REMARKS

Claims 7-14 were examined in the Office Action mailed July 13, 2005.

Fig.1

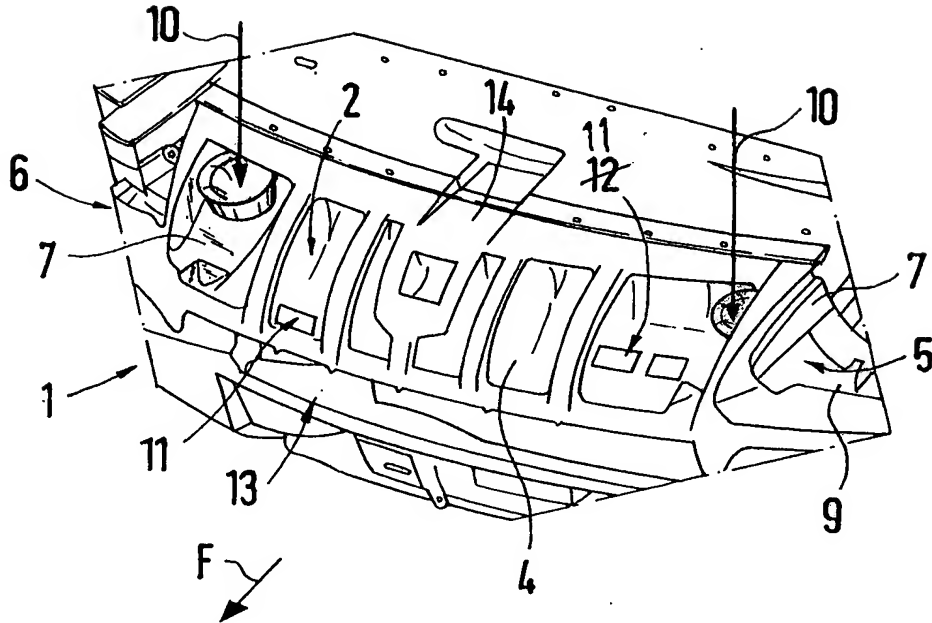
- The first full paragraph on Specification page 5 has been amended to replace the reference to correct the bearing part reference label from 14 to "4," as shown in Fig. 1.

The Applicants have attached hereto for Examiner approval a REPLACEMENT SHEET containing a proposed change to Fig. 1 to correct the reference label "12" to "11." A red-ink markup of the proposed change is also attached hereto.
